Preliminary Acceptance Punchlist
El Paso County – Department of Public Works - Stormwater Section

Project Name:	Bent Grass Residential F2
EDARP Filing Number(s):	SF1914, CON2022
ESQCP Number:	ESQ228
Attendees:	DPW SW: Dylan Finley, Ben Jones DPW Development Services: Spencer Pirzadeh, Brad Walters Developer: George Hart, Erin Ganaway
Date of Walk-Thru:	09/13/2023
Walk-Thru Number:	1

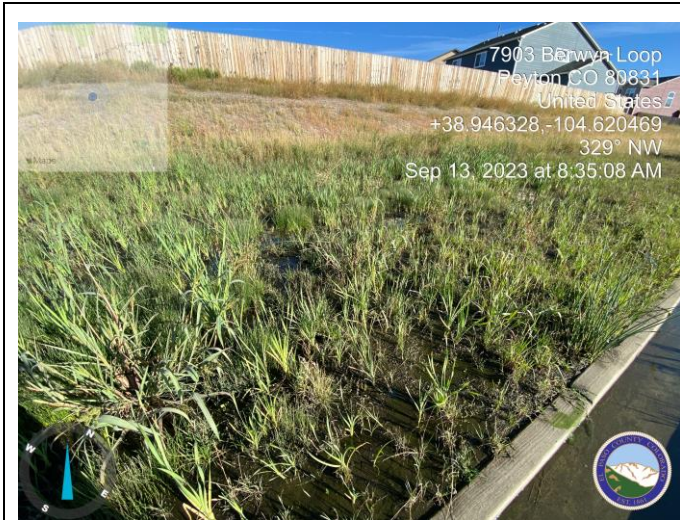
Photo 1: Swale A has standing water at point near channel. Cat tails present. Sediment eroding into channel. Regrade and stabilize.

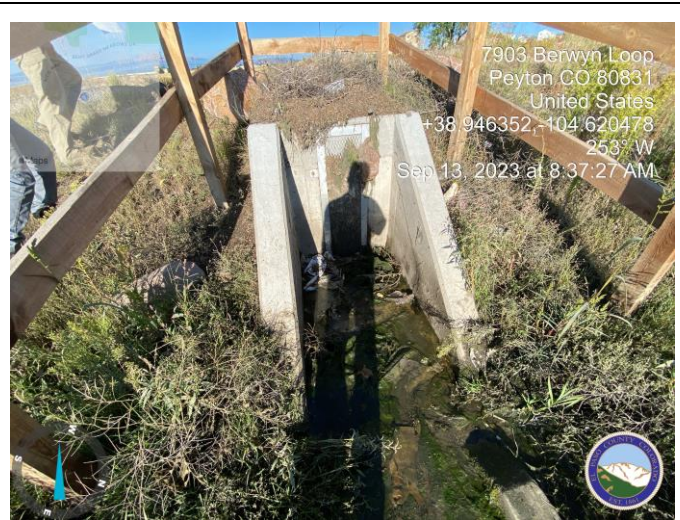
Photo 2: (South Pond) Outlet structure inspection could not be completed because of amount of debris covering it. The PA inspection will be completed once debris is removed.

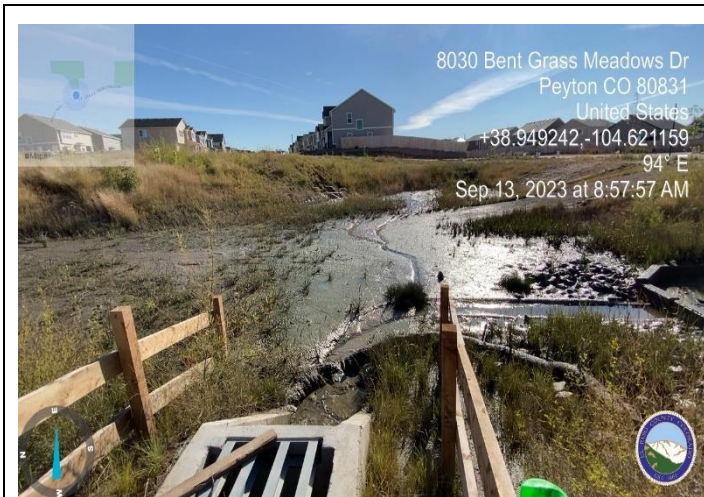
Photo 3: Remove sediment and debris throughout pond. Grade pond to top of trickle channel curb. Grade pond bottom to min 3% slope towards trickle channel.

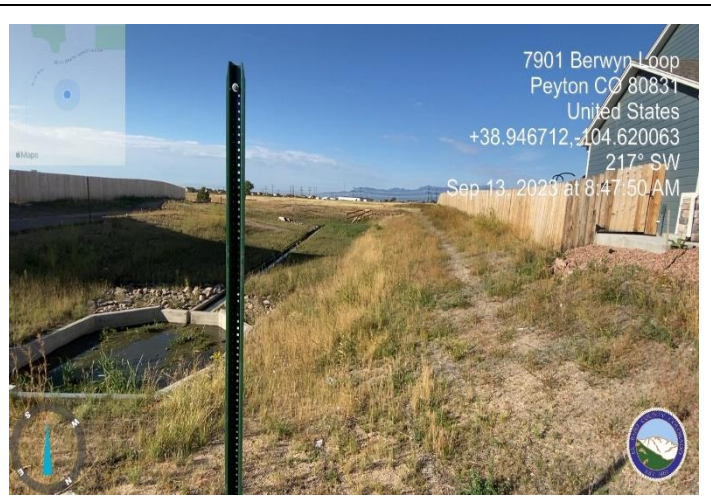
Photo 4: Signage for permanent ponds missing at both ponds.

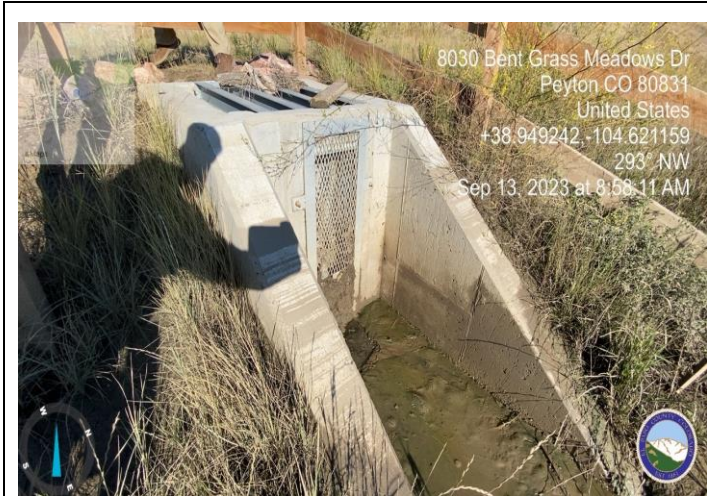
Photo 5: Well screen type not acceptable: diamond plate not allowed. Drawing calls for Johnson vee wire. See sheet G6.01

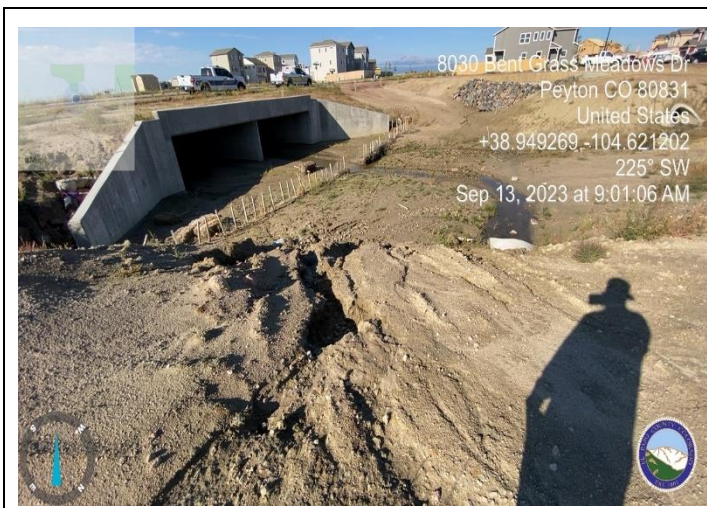
Photo 7: North pond outfall near cutoff wall eroding. Regrade and stabilize.

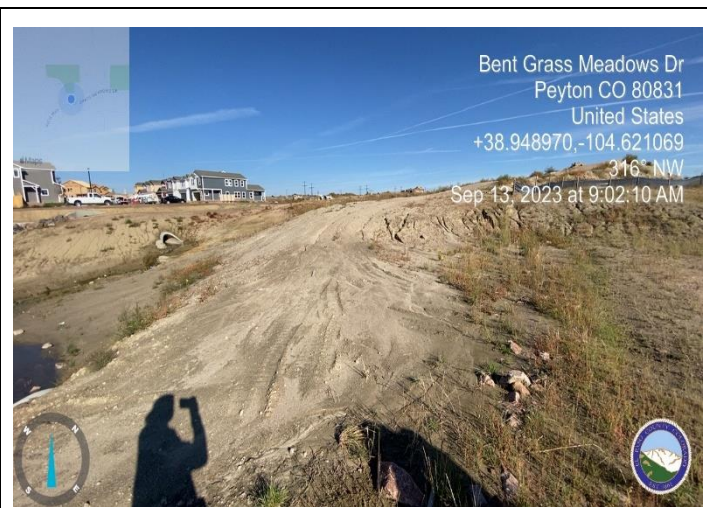
Photo 8: The grade of the north side of the spillway has been raised due to an adjacent temporary access road. This appears to be causing the erosion at cutoff wall. Regrade north side of spillway per plan.

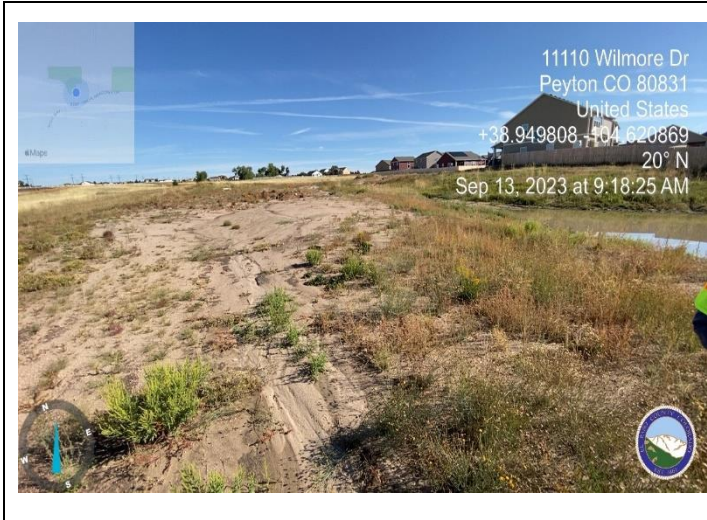
Photo 9: Install Swale B (which is tributary to North pond) per plan. See GEC Plan Sheet G2.03 and G5.01.

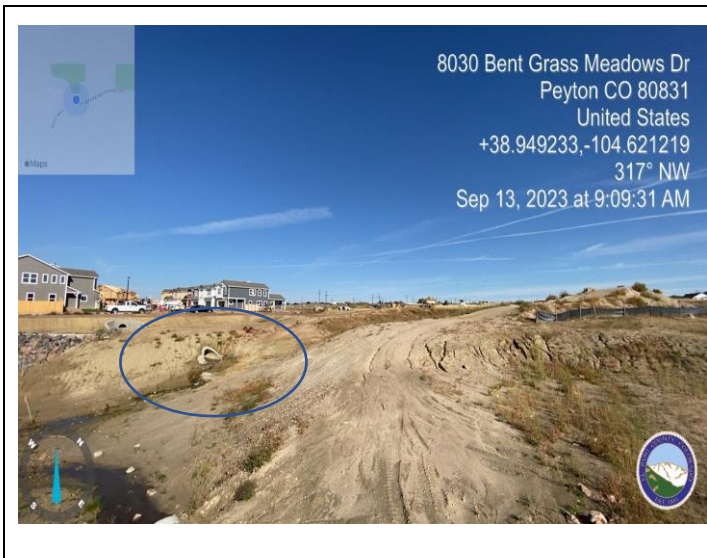
Photo 11: Install drop structure and other improvements in main channel (West of Swale B). See GEC Plan Sheet G7.02.

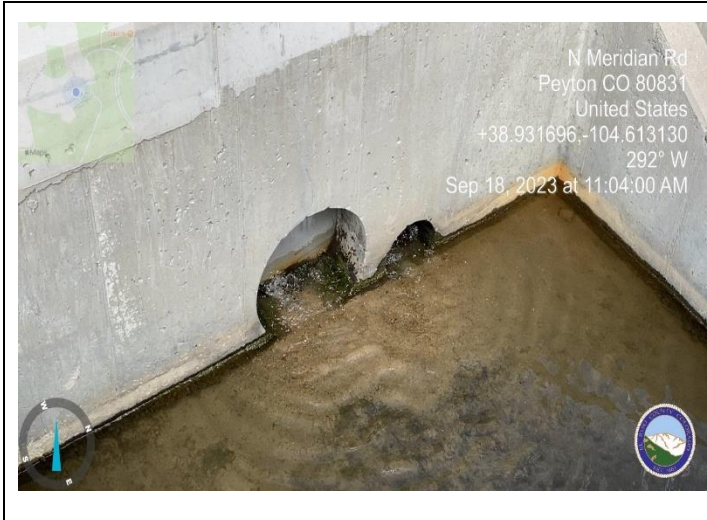
Photo 13: (Pond WU) Gaskets missing from all orifice plates. Install the watertight seal per spec. (GEC page 6.06)
